**NOTICE OF APPEAL**

Department of Environmental Protect (“DEP”) email dated April 22, 2026, rejecting Appellant’s sampling plan for a proposed closure in place of a petroleum underground storage tank (“UST”). Copy attached as Exhibit A.

The operation is a Speedway LLC retail fuel service station and convenience store located at 1043 Lehigh St, Allentown, PA 18103 in Lehigh County (the "Store").

**Subject:** [External] 7-Eleven 45778-6747 1043 Lehigh Str., Allentown PA: Proposed Closure in Place (CIP) sampling

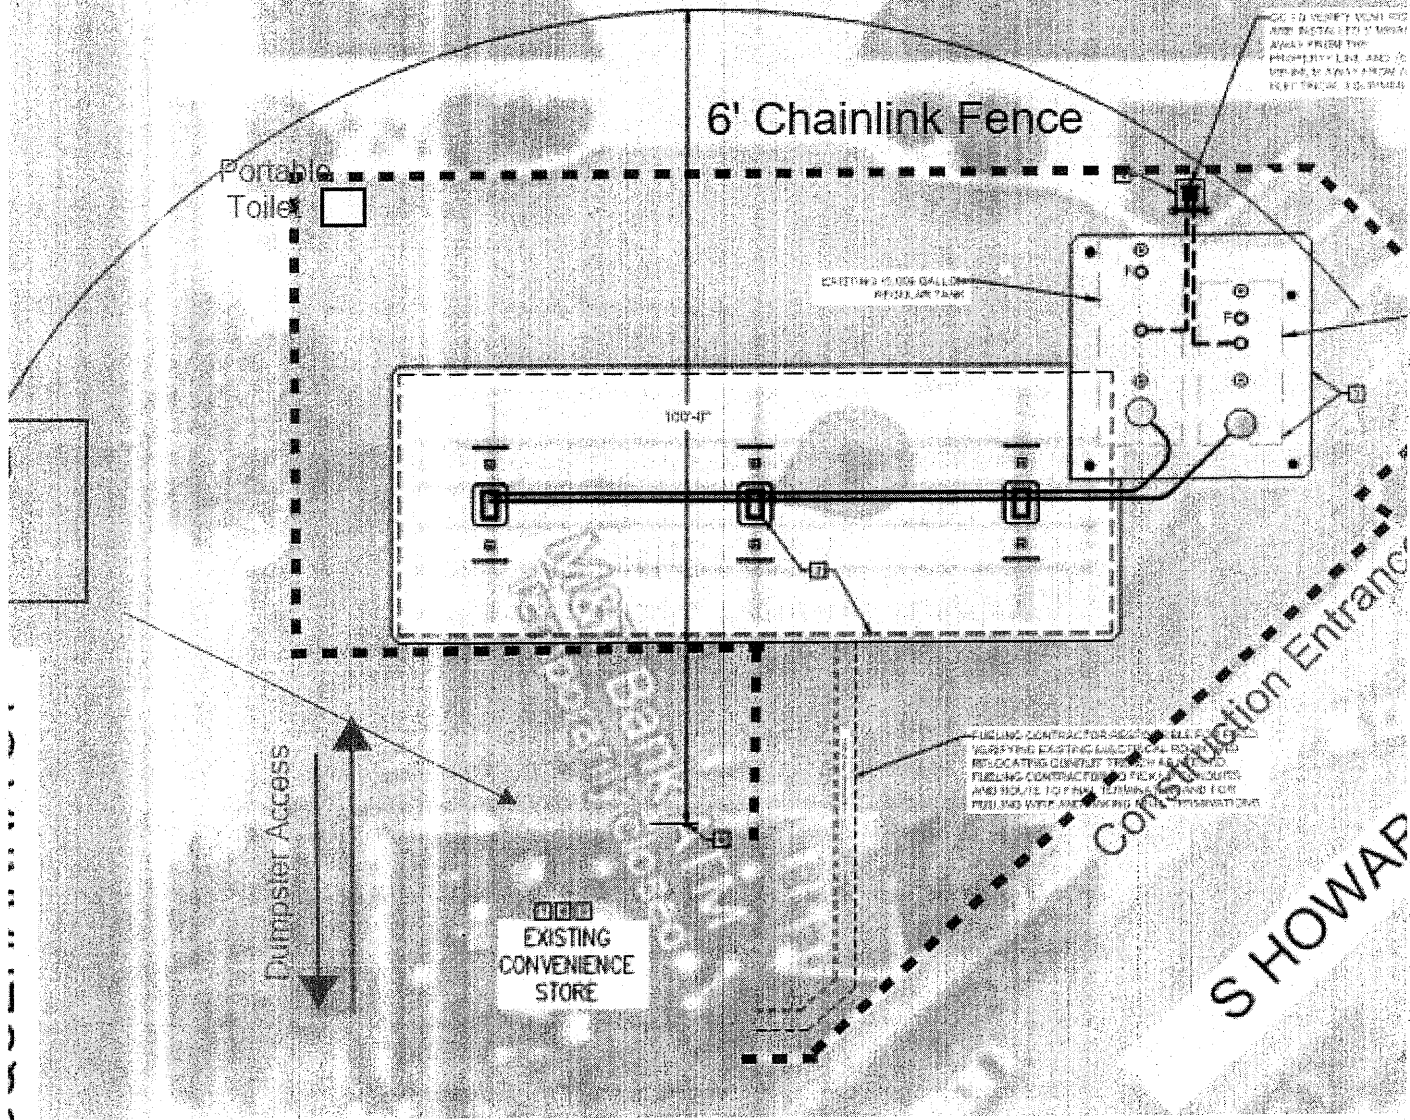
The DEP UST Closure guidance details the sampling protocol for closure in place (see pages 26-30). The proposed sampling locations do not meet the guidance, so we cannot accept this proposal. If there is underground piping that is being abandoned in place, then you may have to collect confirmatory soil samples for piping as well; please see page 17 of the guidance. In addition, the sampling locations are to be no more than 5' from the tank/piping systems. As such, if AECOM's policy is that no borings can be conducted within 7' of the underground systems, then 7-Eleven will need to find another contractor which can.

Since the UST will need to be cleaned before filling it with grout, you may want to consider accessing the UST through the tank top, cleaning the tank, then coring directly through the tank bottom. If there's anticipated water within the tank excavation zone, then this not an ideal option; it also lends to the possibility of collecting grab water samples with each soil boring where water is encountered.
